SUBJECT: CAROLINA POWER & LIGHT COMPANY; ORGANIZATIONAL CHANGES;
H. B. ROBINSON STEAM ELECTRIC PLANT, UNIT NO. 2. (TAC NO. 64900)

Amendment No. 114
License No. DPR-23

ATTACHMENT TO LICENSE AMENDMENT NO. 114

SAFETY EVALUATION BY THE OFFICE OF NUCLEAR REACTOR REGULATION
RELATED TO AMENDMENT NO. 114 TO FACILITY OPERATING LICENSE NO. DPR-23

Figure 6.2-2

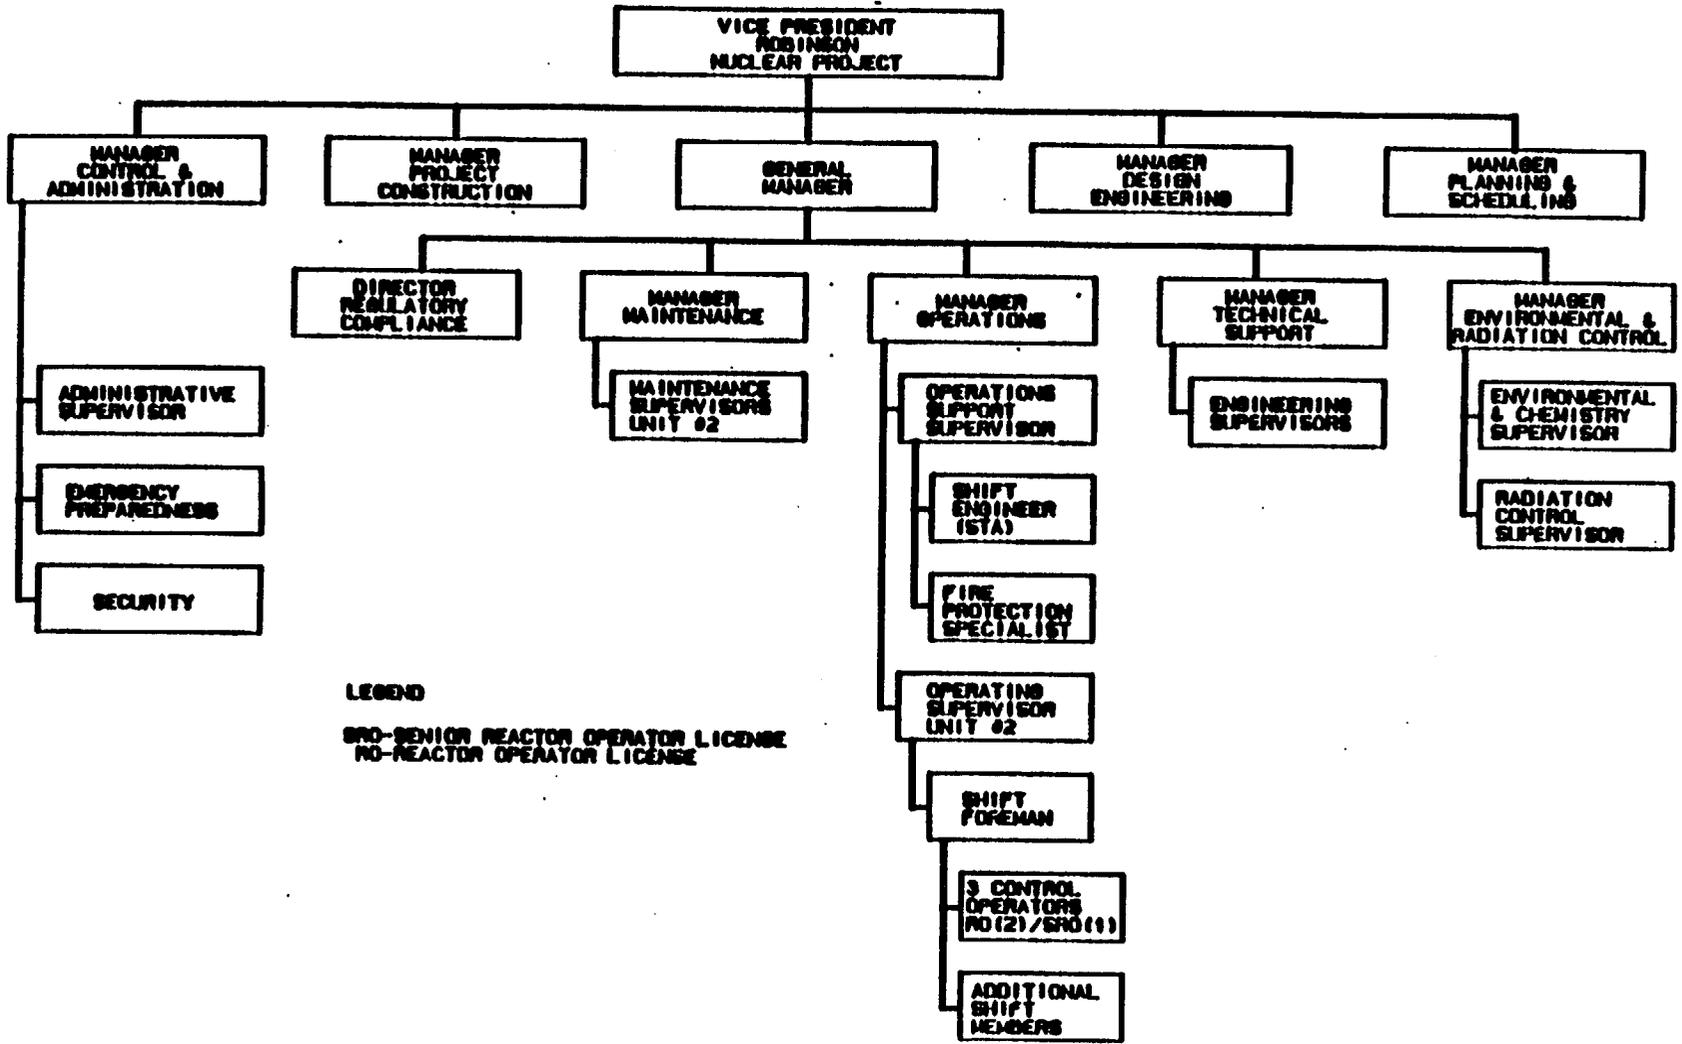
- A. The title of the Manager-Robinson Nuclear Project is to be changed to Vice President-Robinson Nuclear Project. Because this is a change of title only and does not affect job responsibilities or reporting relationships, we find it acceptable.

- B. The title of the Director-Training is to be changed to Manager-Training. Because this is a change of title only and does not affect job responsibilities or reporting relationships, we find it acceptable.
